Duke Power Company  
Oconee Nuclear Station

Attachment 1

15 EFPY Pressure/Temperature Limits

Low Temperature Overpressure Protection Technical Justification

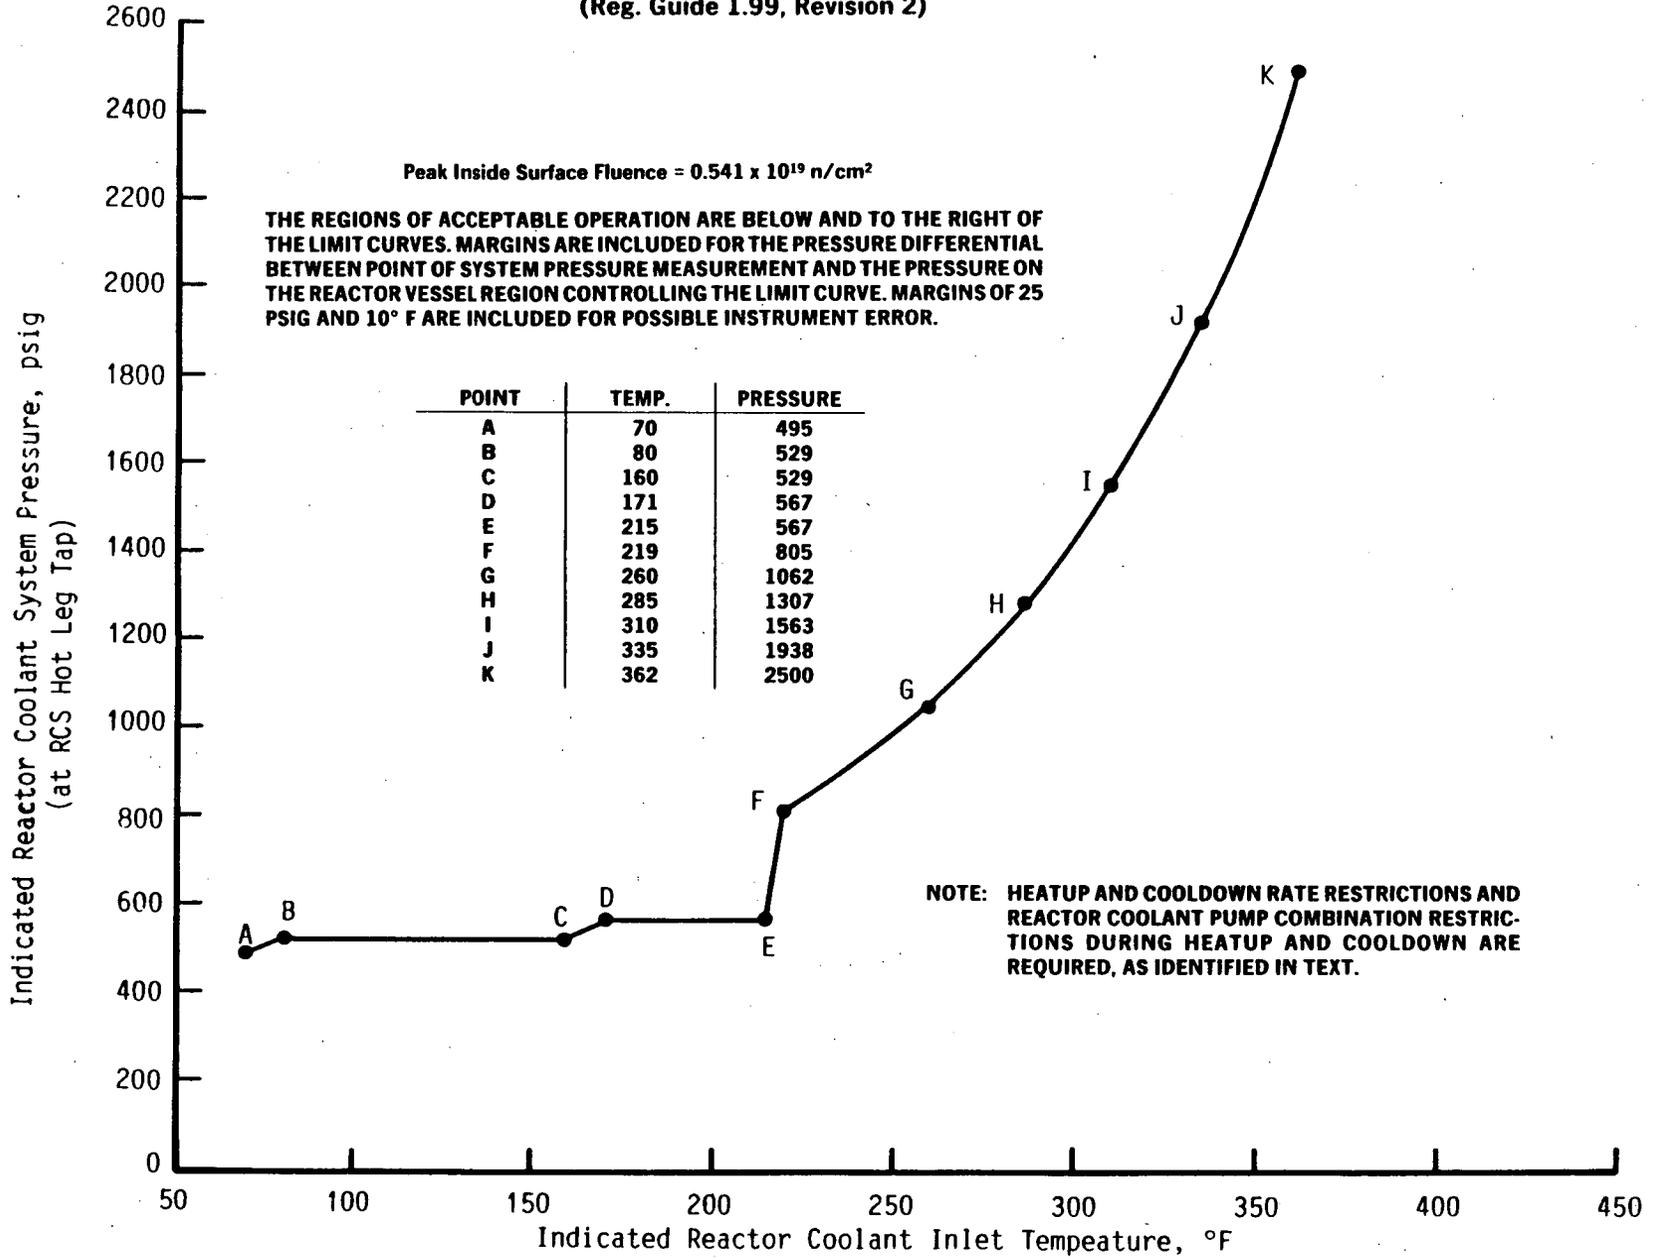
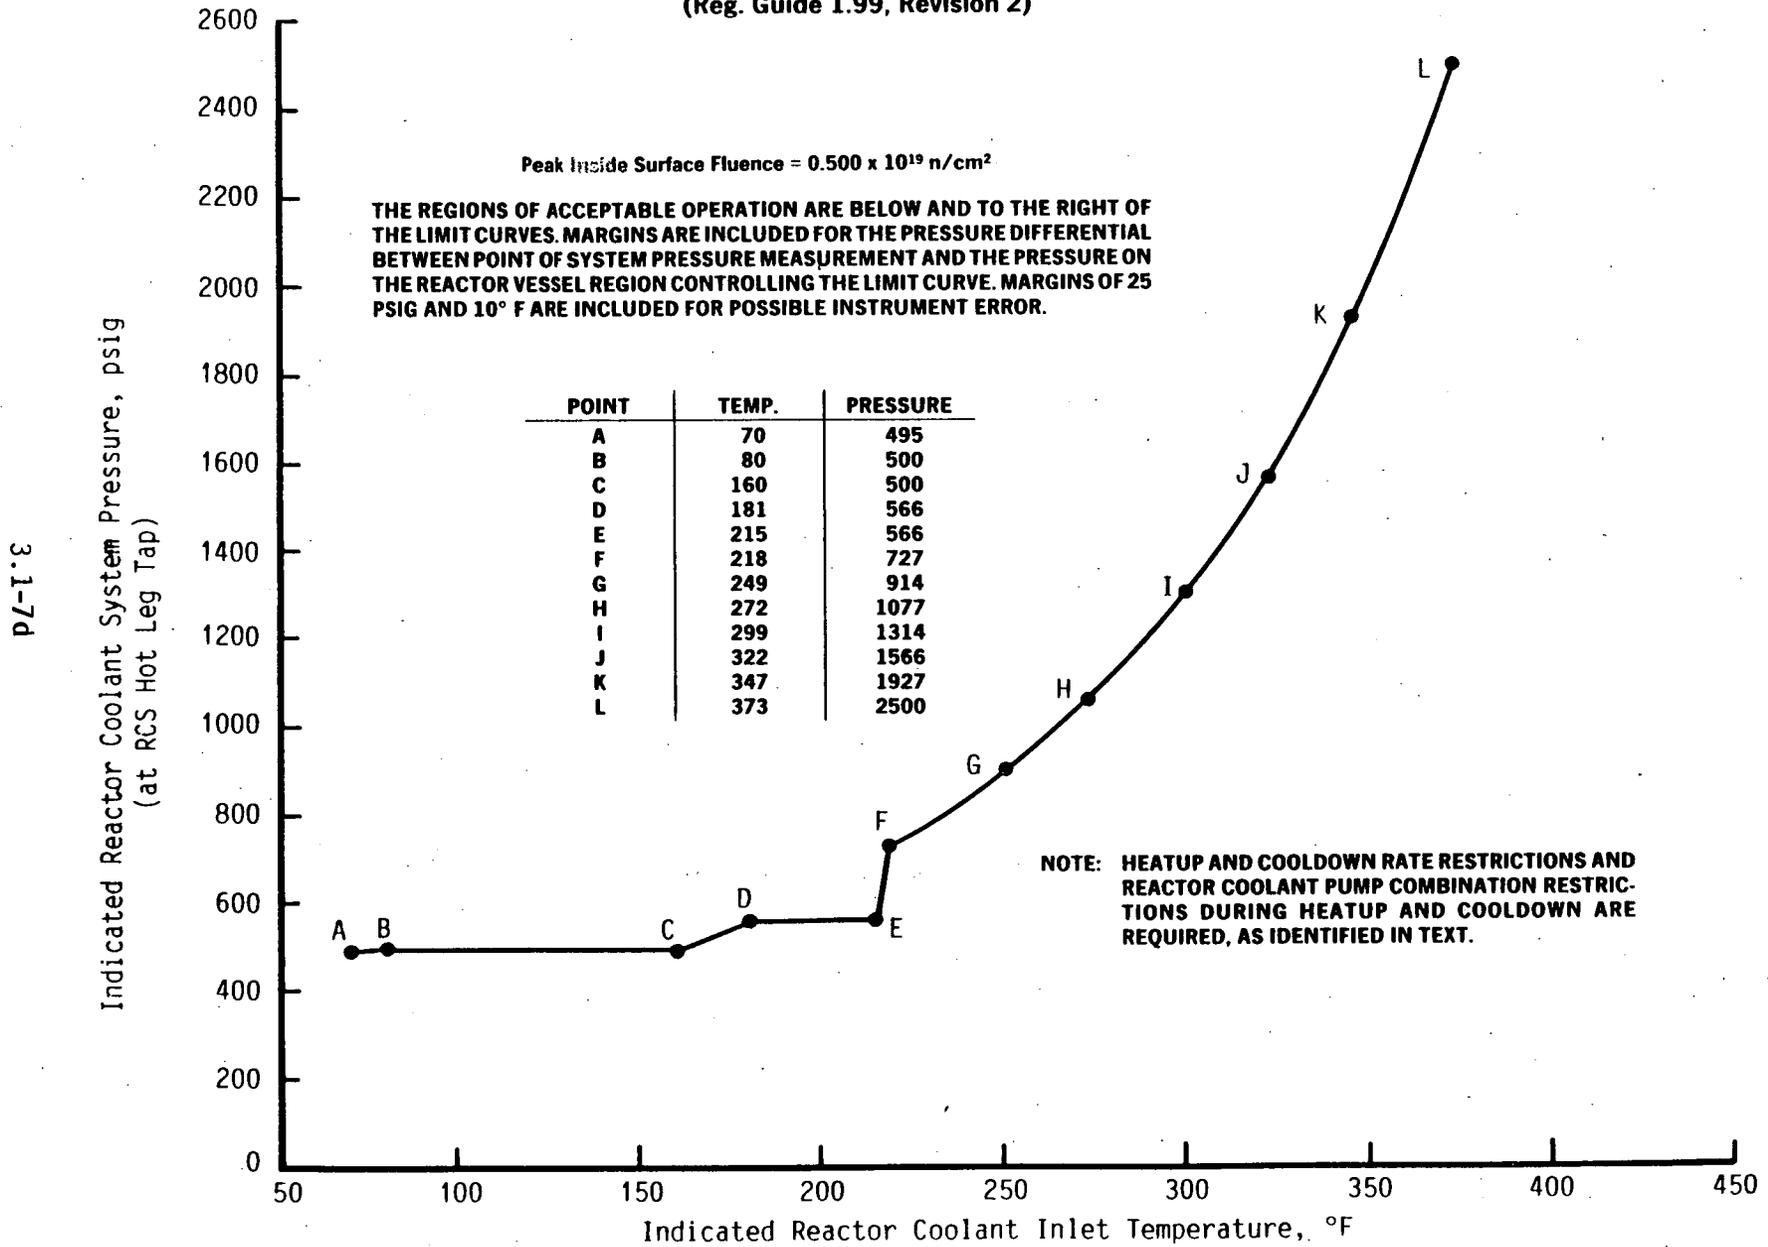
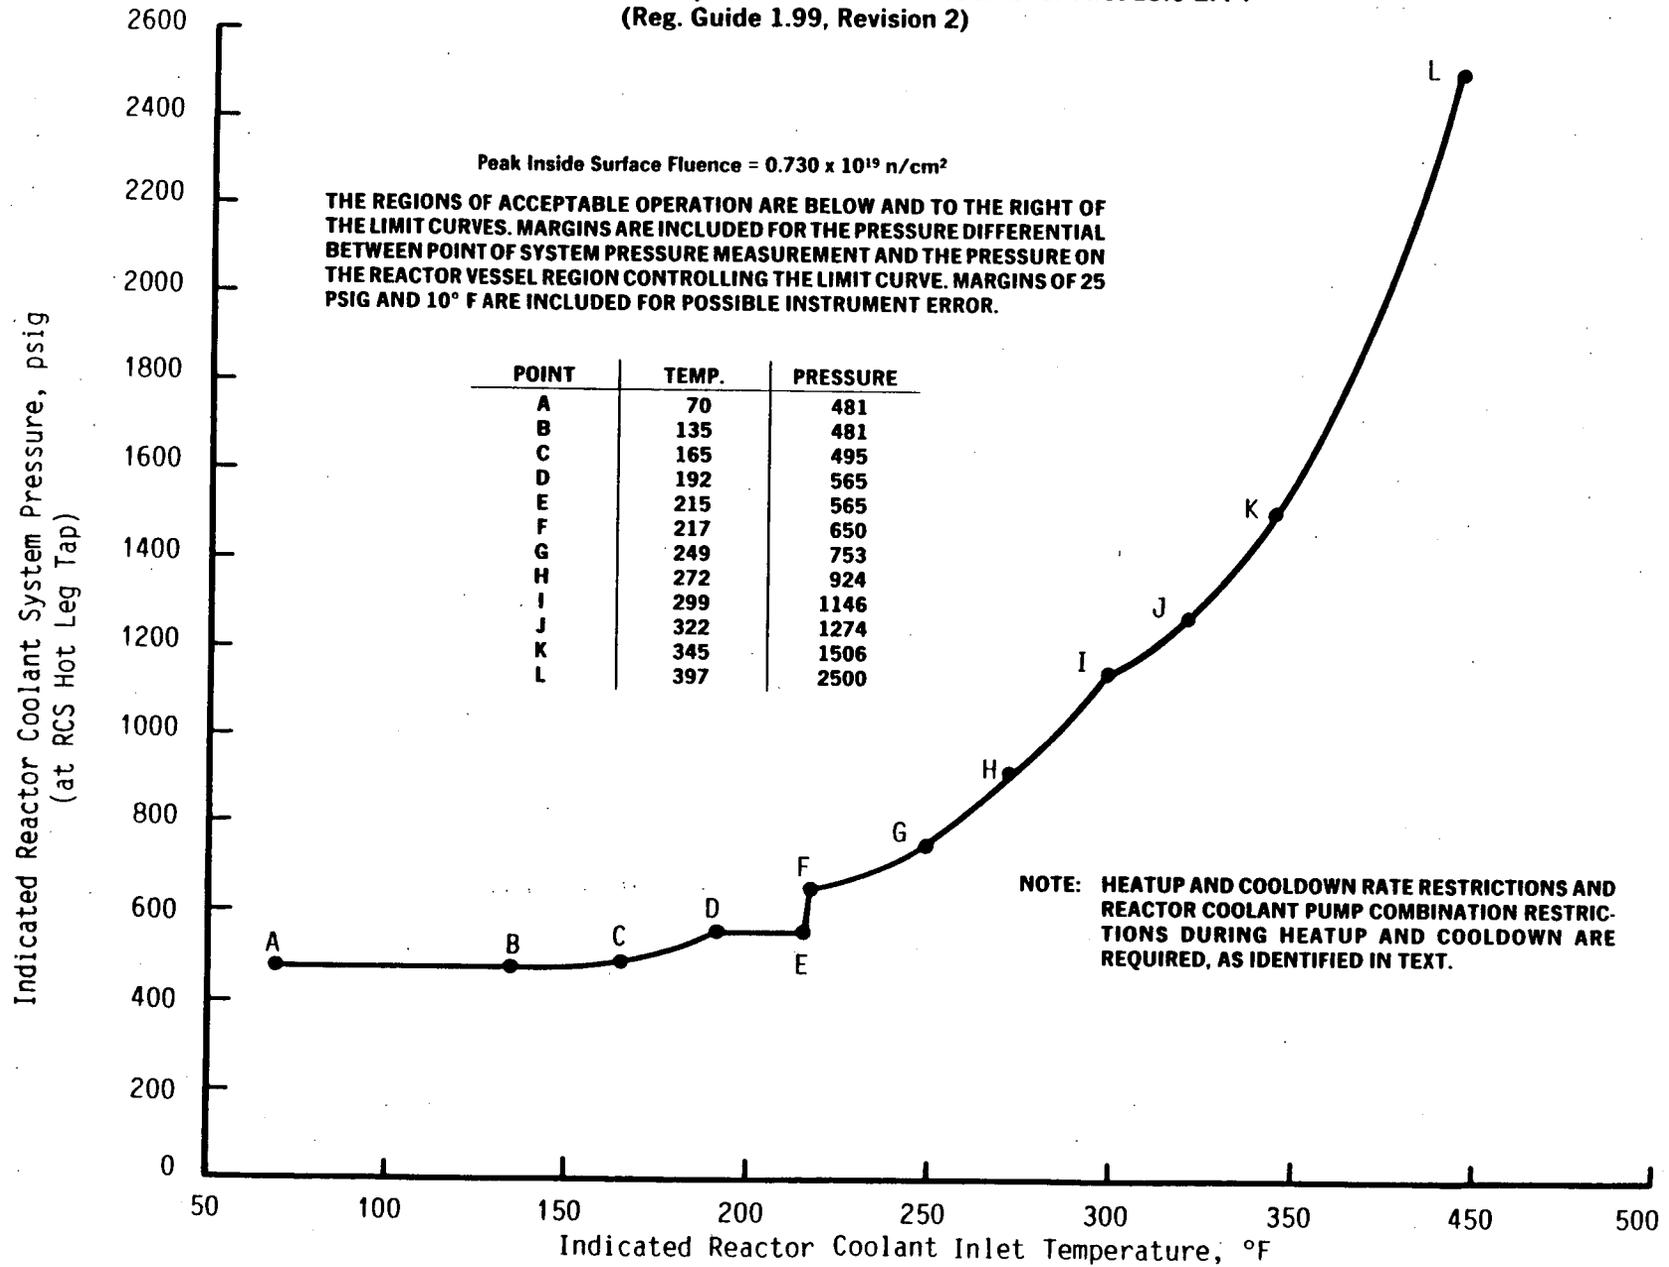
The proposed pressure-temperature limits for low temperature operations are provided by the inservice leak and hydrostatic test curves for heatup and cooldown. These curves have been developed in accordance with Appendix G methodology and incorporate a safety factor of 1.5 (Reference 8). The NRC staff has recognized as acceptable the use of the hydrostatic curves to establish the LTOP System setpoints, as long as a pressurizer gas bubble exists (Reference 9). The Oconee units are always operated with either a steam or nitrogen bubble in the pressurizer.

TIME (SECONDS)  
Figure 1

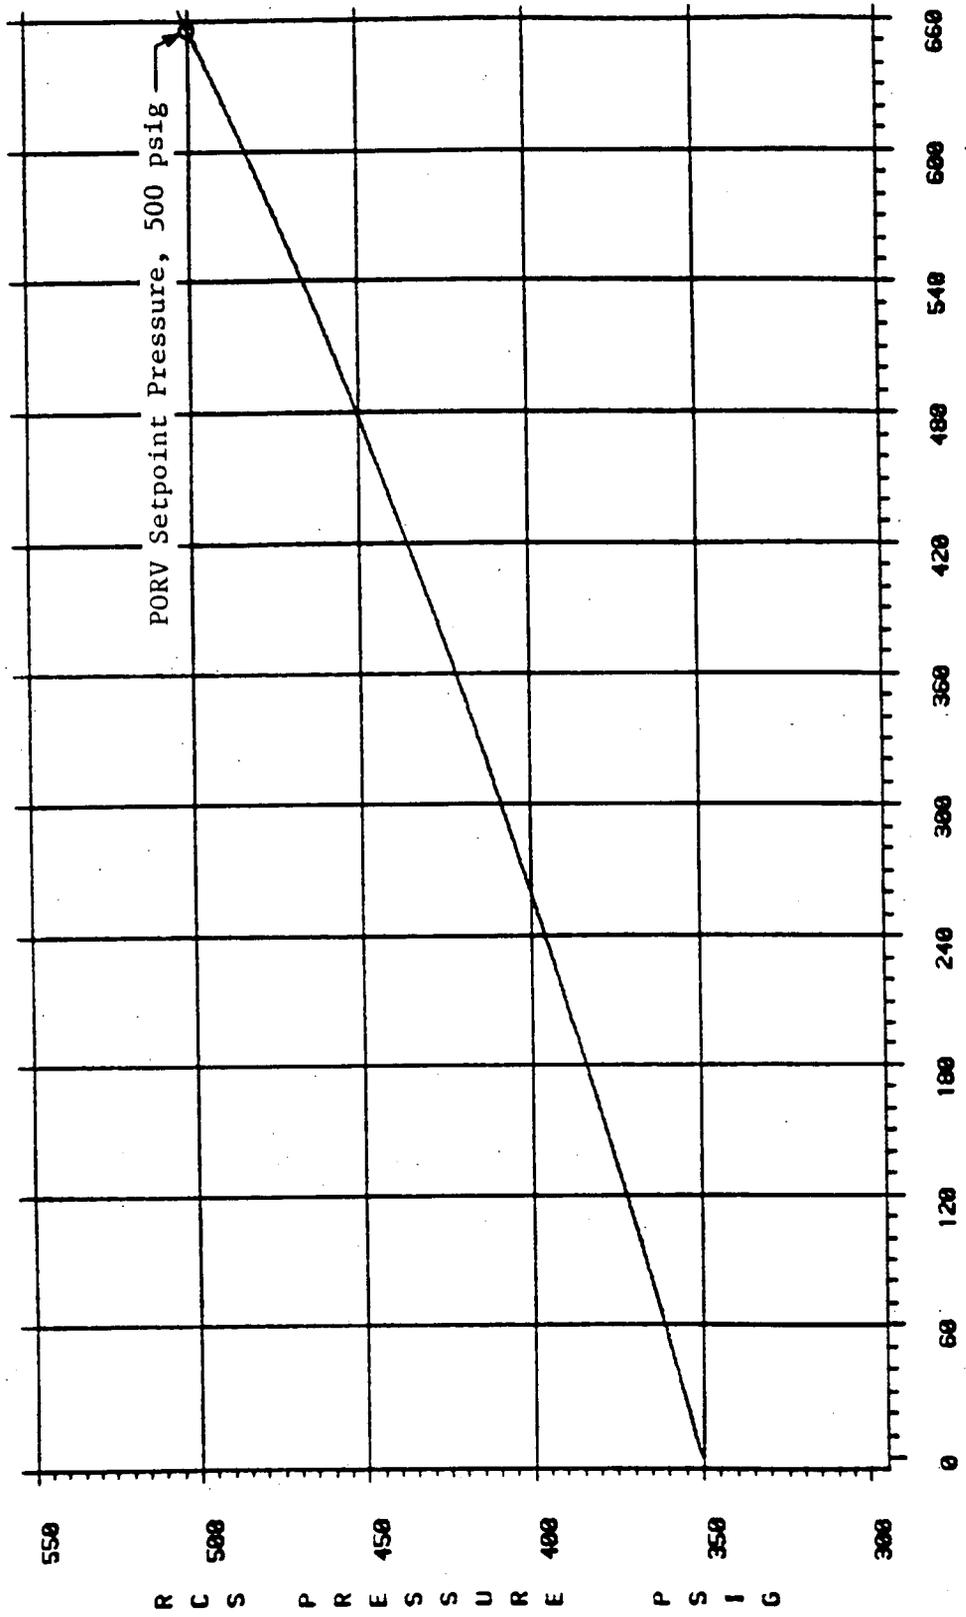
Figure 1 shows the transient pressure response associated with this scenario, for Oconee Units 1 and 2. The pressure response for Unit 3 is very similar. In each case, at least 10 minutes is available between the start of the transient and the time the pressurizer pressure reaches 500 psig (480 psig for Unit 3). The maximum allowable pressurizer pressure and level for operations with the RCS temperature below 220°F are determined by the initial conditions of this analysis.

Figure 2

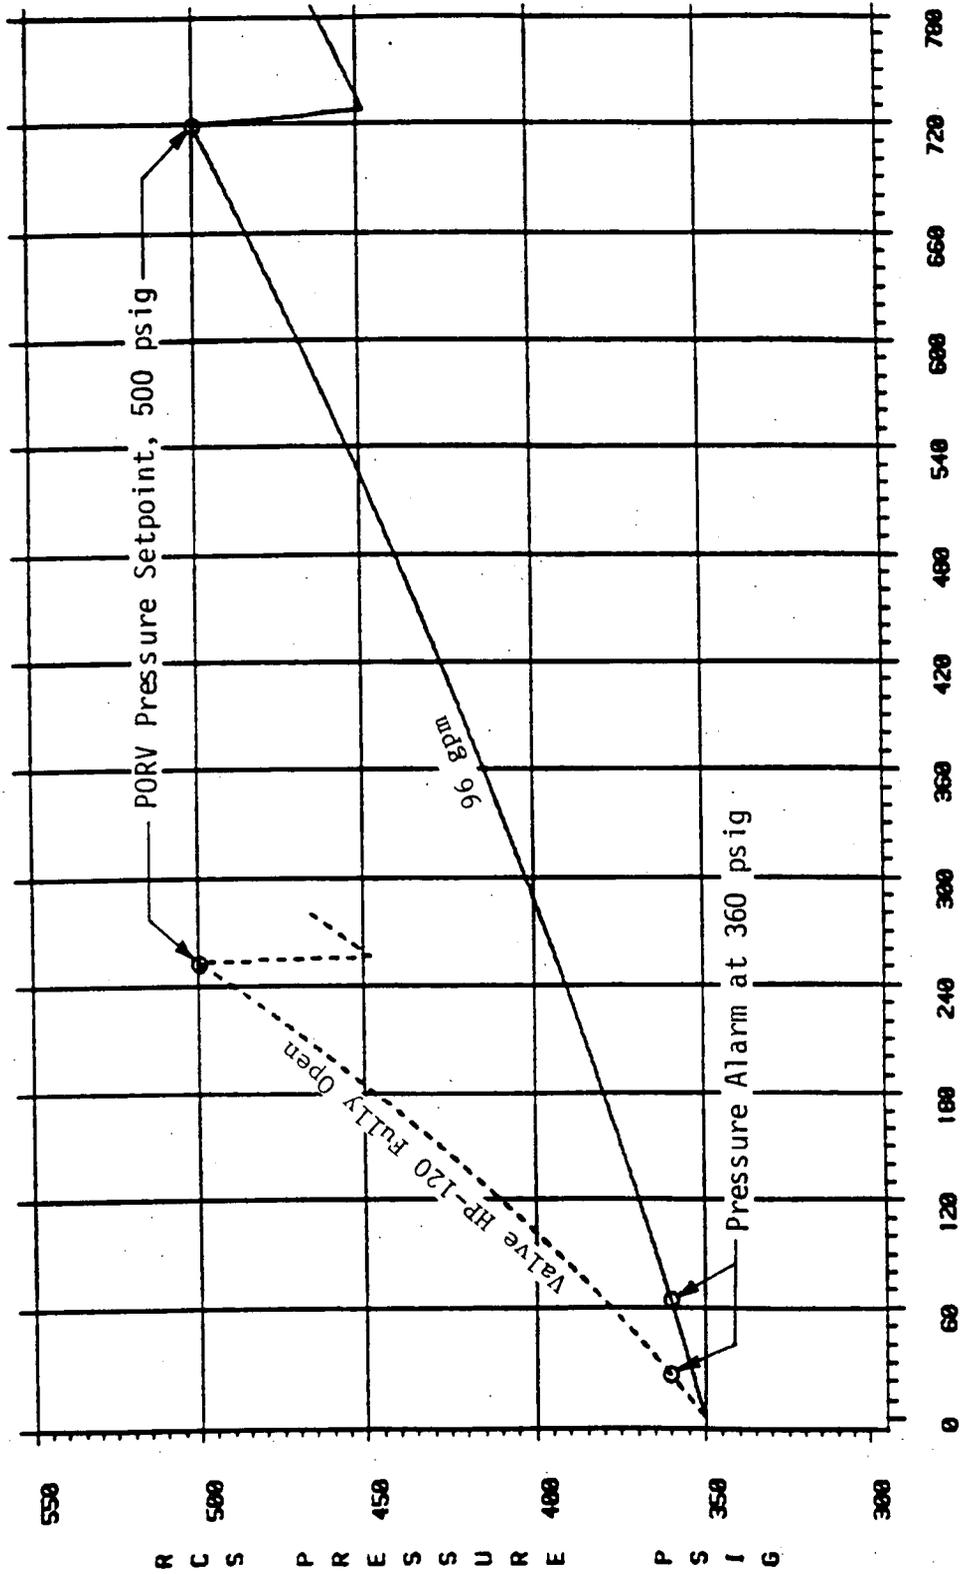
As shown in Figure 2, this scenario will cause the RCS pressure to increase above the new pressure and temperature limits in under 10 minutes. As a result, Duke Power Company has decided to restrict flow through the makeup path in order to meet the 10 minute operator inaction criterion. The maximum allowable flow rate through the makeup path is determined in the following manner for each Oconee unit:

For an example, Figure 2 shows that flow through the makeup path has to be restricted to about 100 gpm or so, if a pressure alarm is assumed to actuate at 360 psig.

Figure 3

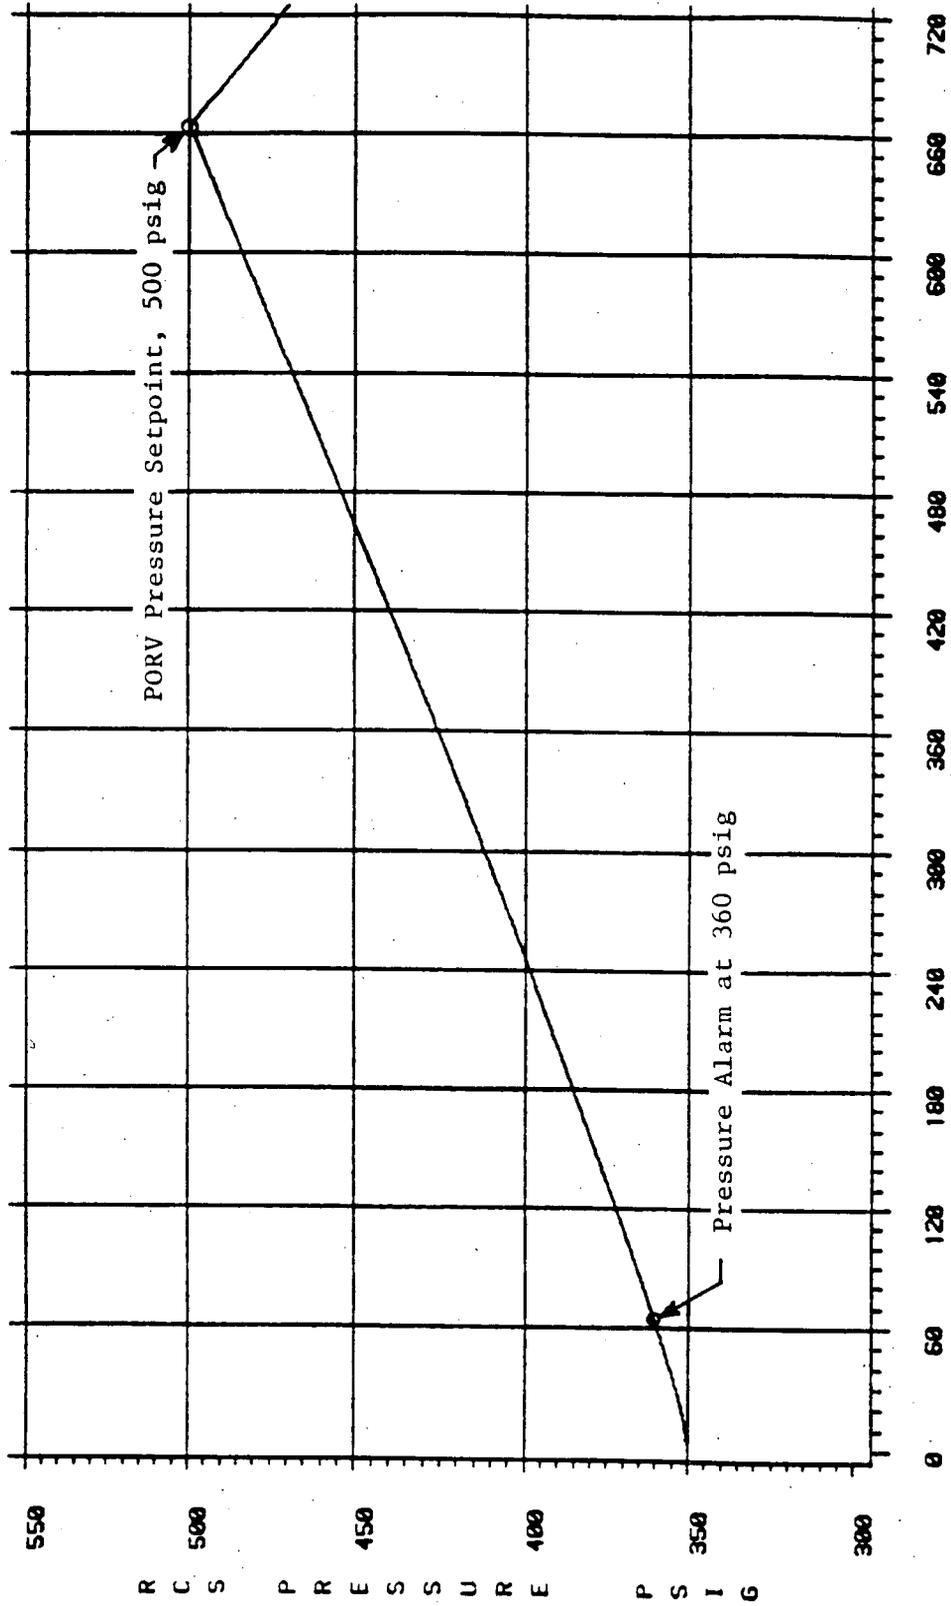
As mentioned previously, the minimum allowable pressurizer level will provide at least 10 minutes between the first alarm and the time the pressure-temperature limits are reached, for the most limiting initial conditions. For example, if a pressure alarm is assumed to actuate at 360 psig, the indicated pressurizer level must be maintained above 102 inches for Units 1 and 2 (refer to Figure 3).
